Project Name: Madison Yards at Hill Farms

City of Madison Site Plan Verification

PROJECT: LNDUSE-2017-00130

Description: Approve General Development Plan for redevelopment of portion of the Hill Farms State Office Property and preliminary plat to create seven lots for State office building and parking structure and proposed mixed-use development.

FIGURE 12 - FIRE ACCESS DIAGRAM

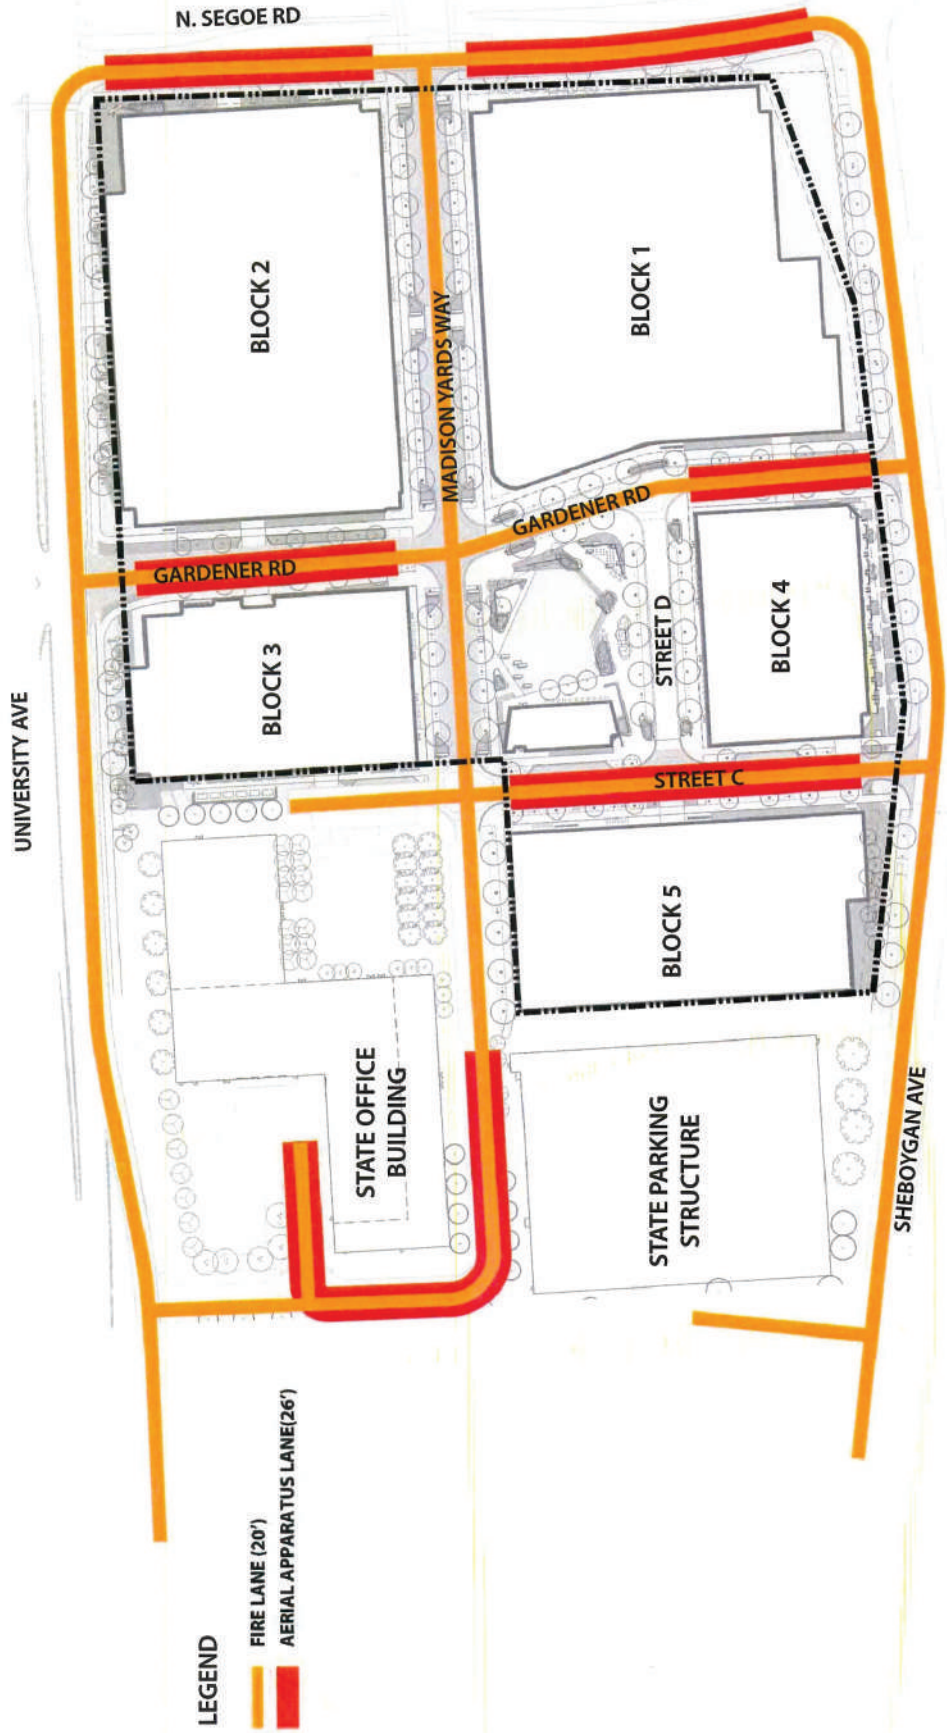
MFD is not opposed to the general development plan. MFD supports the general layout of the proposed fire lanes but may require modifications based on the actual building designs and street scape details.
